HISTORIC AND DESIGN REVIEW COMMISSION

HDRC CASE NO: 2022-255
COMMON NAME: 2219 W Gramercy
LEGAL DESCRIPTION: NCB 6820 BLK LOT 7
ZONING: R-6, H
CITY COUNCIL DIST.: 7
DISTRICT: Monticello Park Historic District
APPLICANT: Michael Clancy
OWNER: James and Jennifer Bailey
TYPE OF WORK: New construction of a 1-story, single-family residential structure
APPLICATION RECEIVED: July 01, 2022
60-DAY REVIEW: Not applicable due to City Council Emergency Orders
CASE MANAGER: Rachel Rettaliata

REQUEST:

The applicant is requesting a Certificate of Appropriateness for approval to construct a new 1-story, single-family residence at 2219 W Gramercy.

STONE
COLOR - LIMESTONE LEUDERS
STYLE - RANDOM

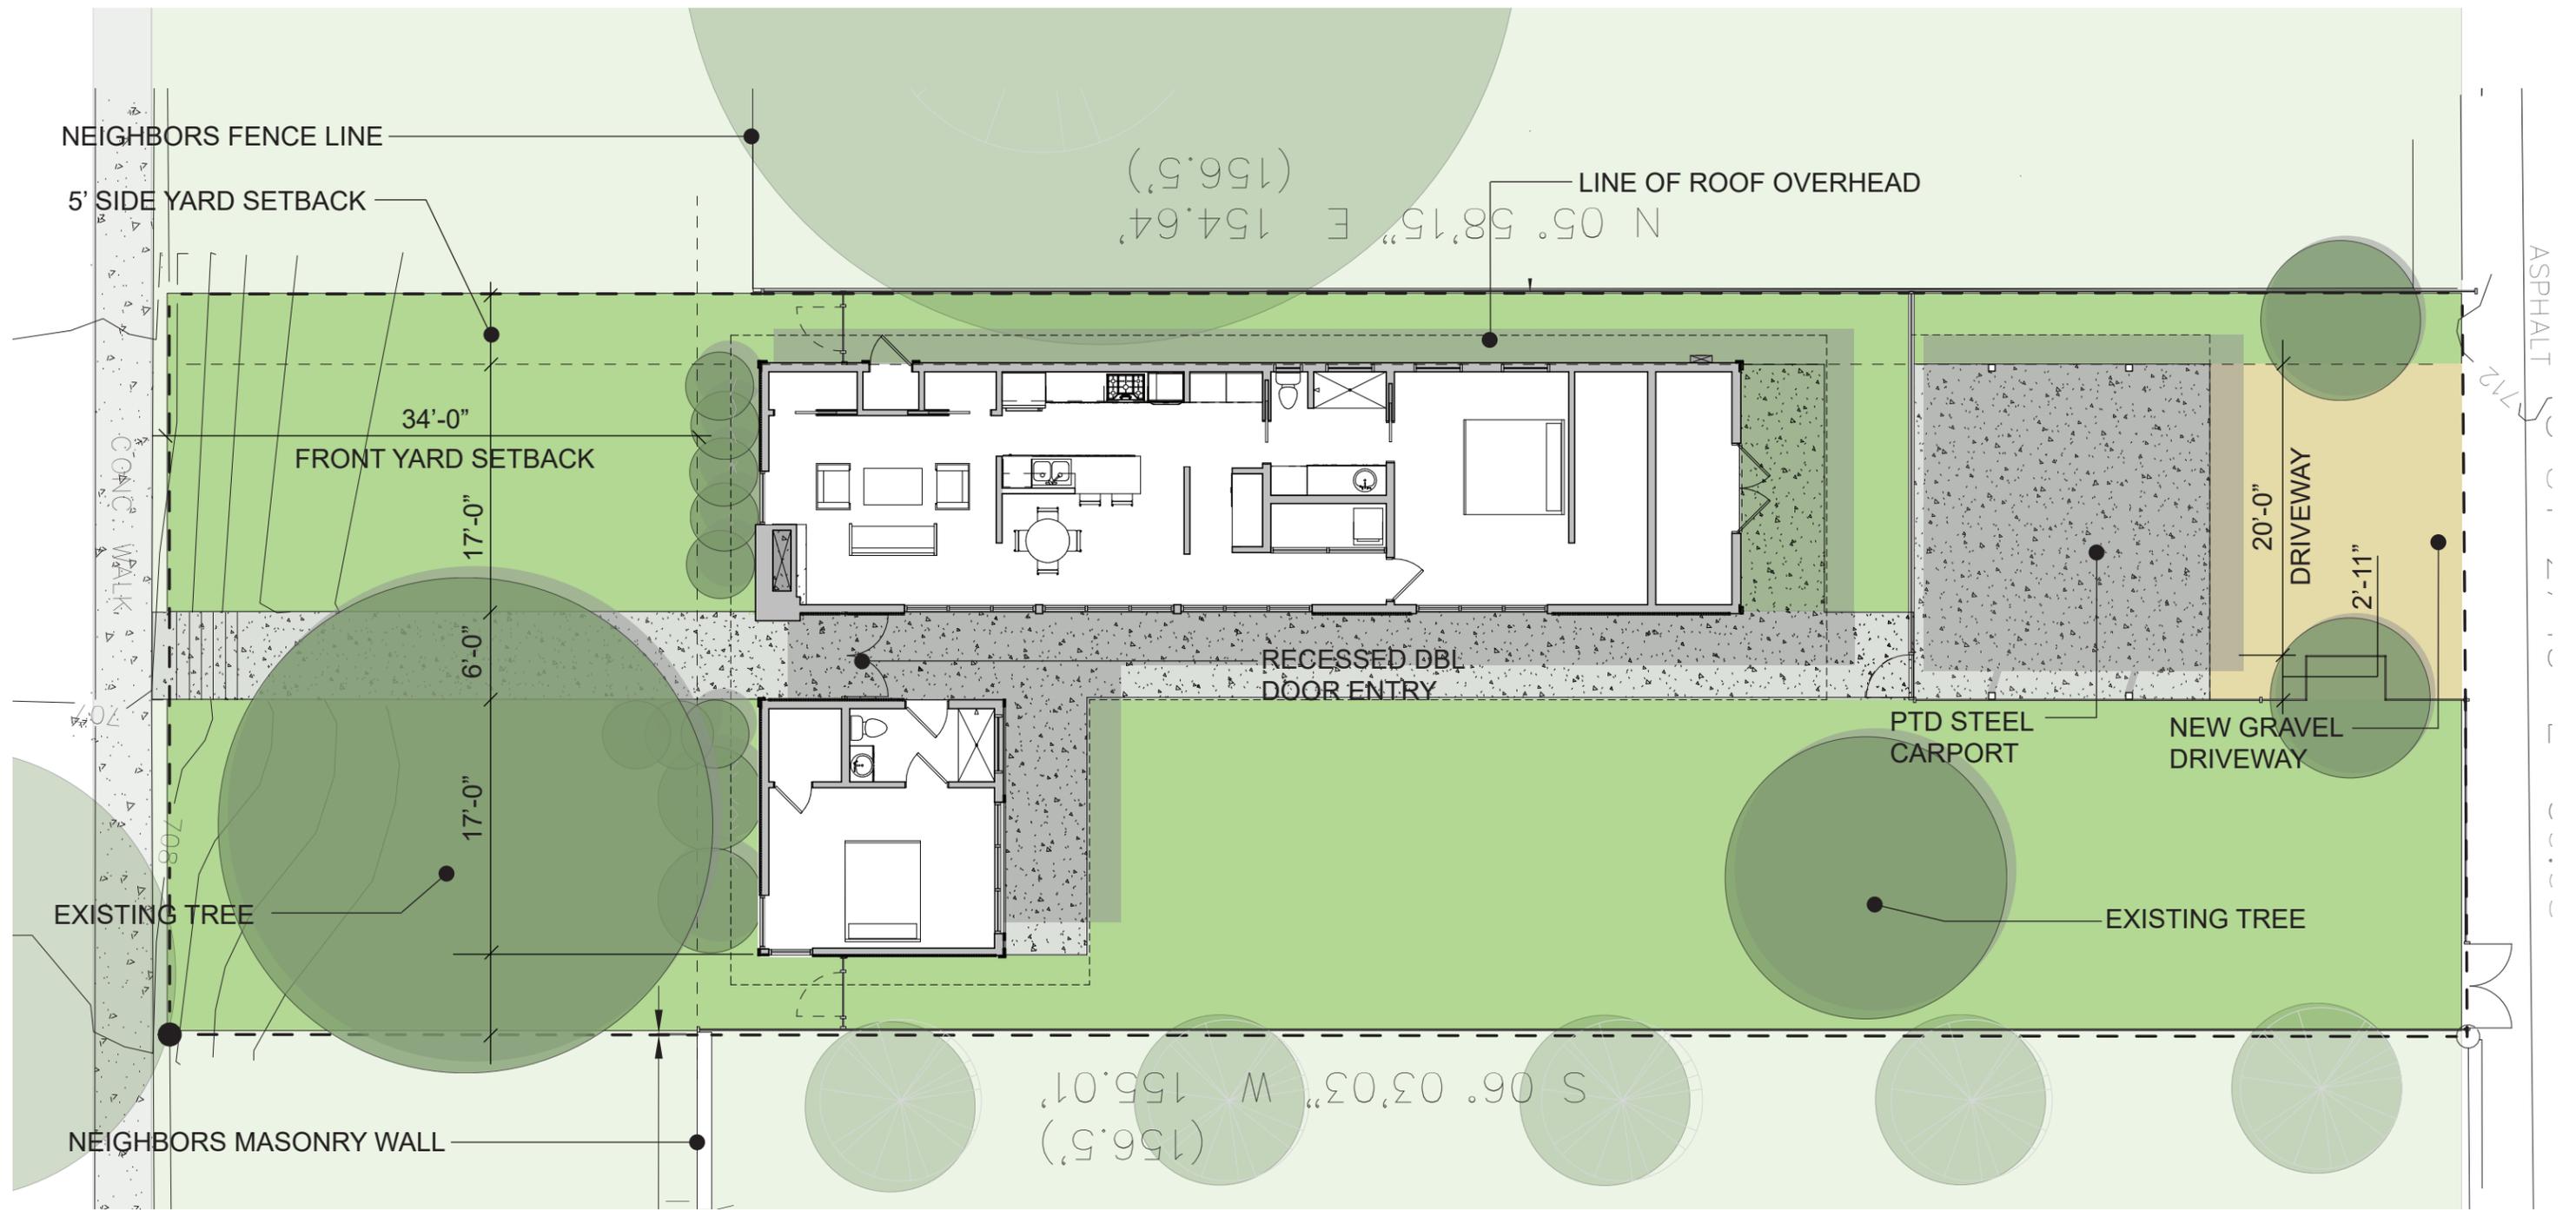
v. That the applicant modifies the proposed cladding to feature rock or stone in keeping with the cladding materials traditionally used in the district.

BASE OF WALL DETAIL
ILLUSTRATING THE RELATIONSHIP BETWEEN FINISH FLOOR AND GRADE.

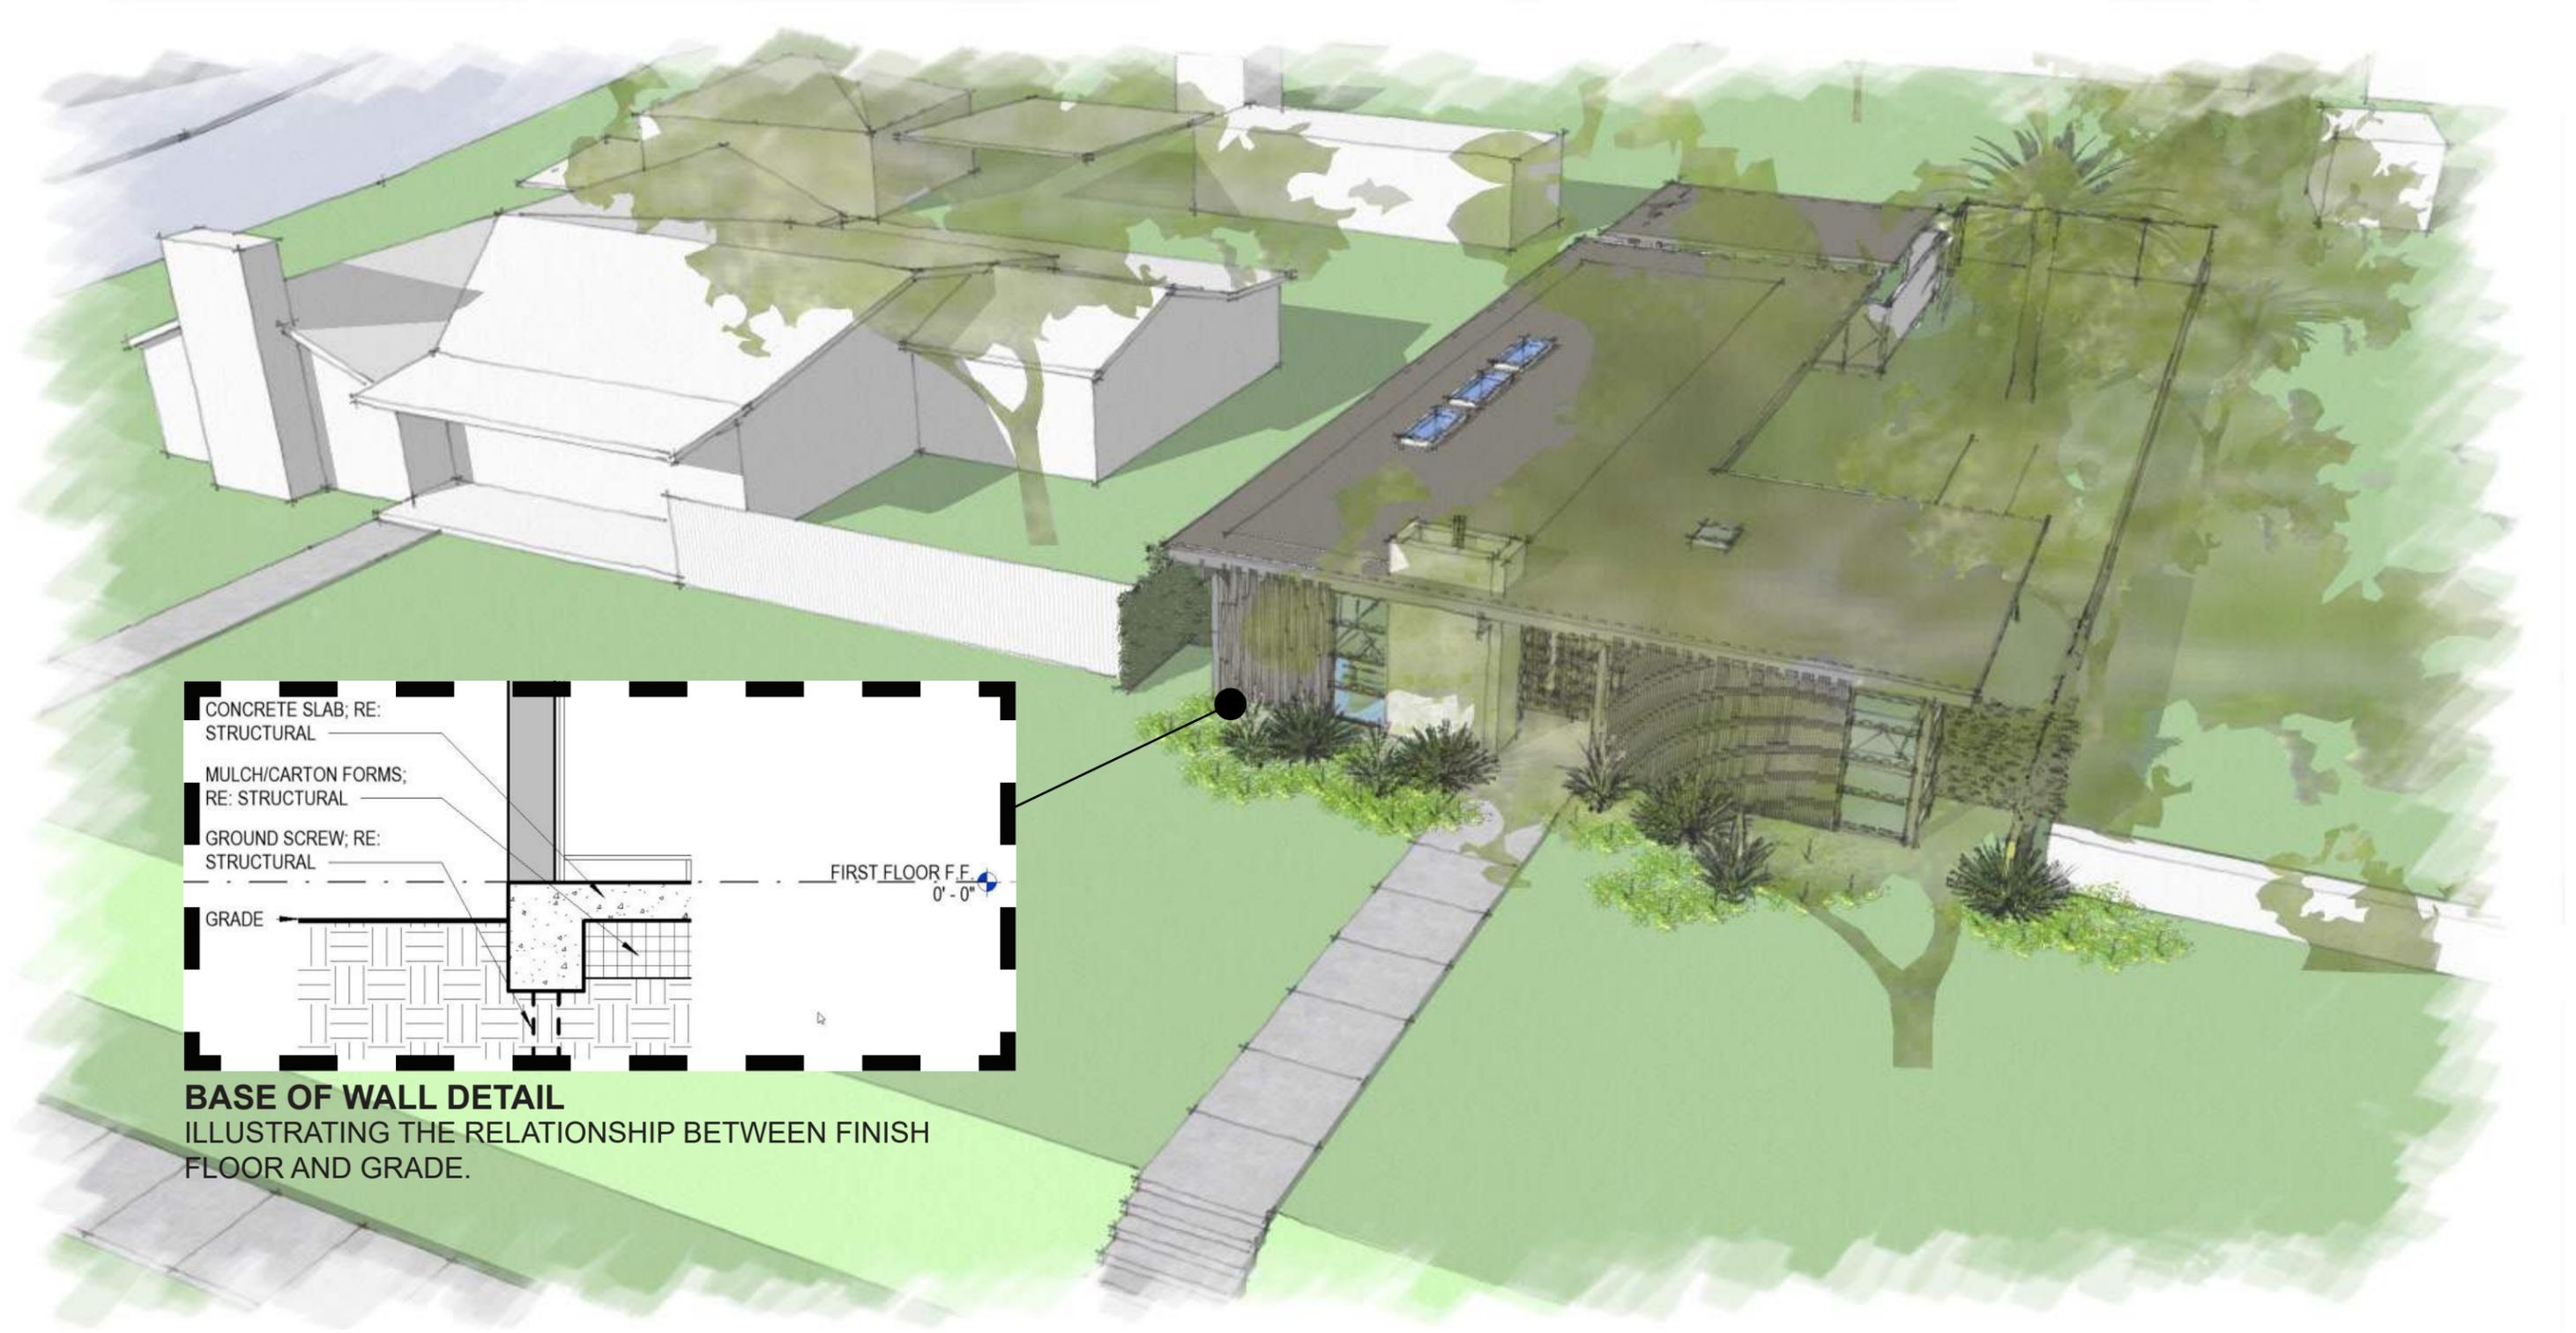
i. That the applicant submits foundation and floor heights showing the scale and massing relative to adjacent structures to staff for review prior to returning to the HDRC based on finding d.

**2219 W. GRAMERCY PLACE - SINGLE FAMILY HOME
MATERIAL PALETTE**

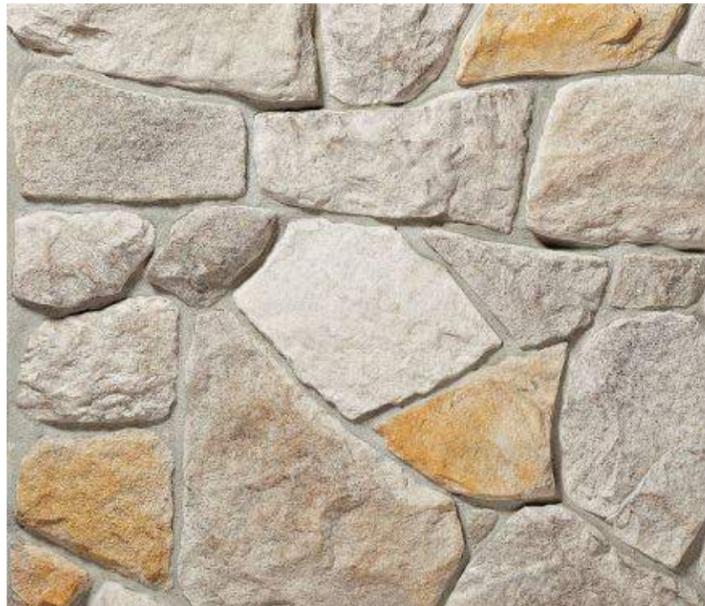
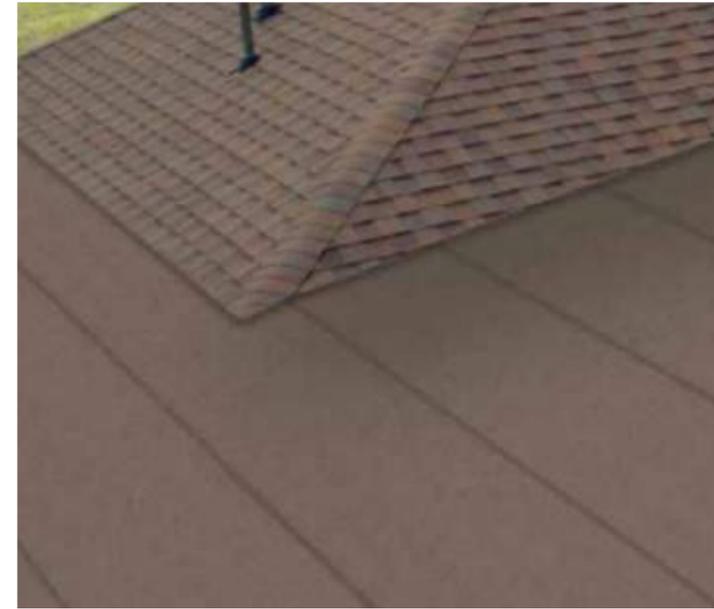
v. That the applicant modifies the proposed cladding to feature rock or stone in keeping with the cladding materials traditionally used in the district.

**2219 W. GRAMERCY PLACE - SINGLE FAMILY HOME
MATERIAL PALETTE**

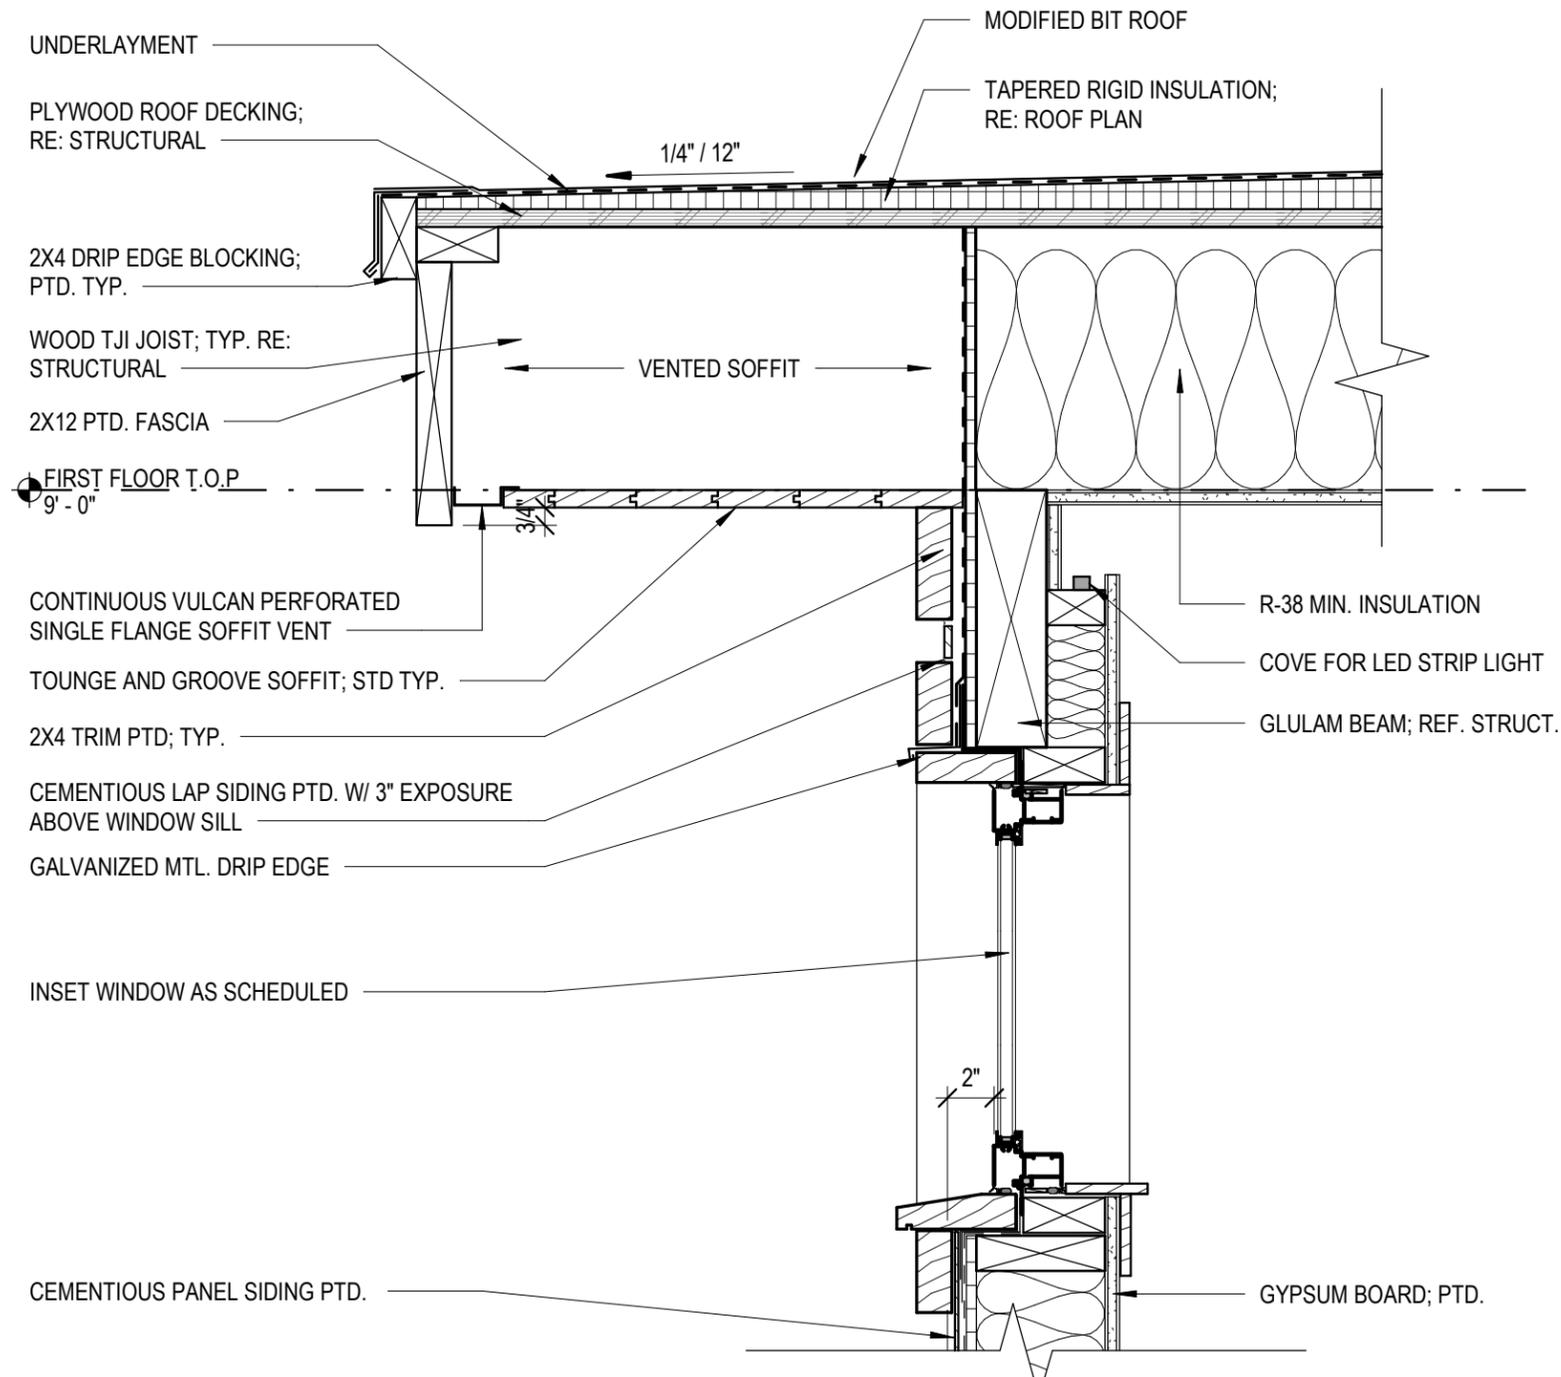
vi. That the applicant proposes a roofing material that is more in keeping with materials commonly found in the district.
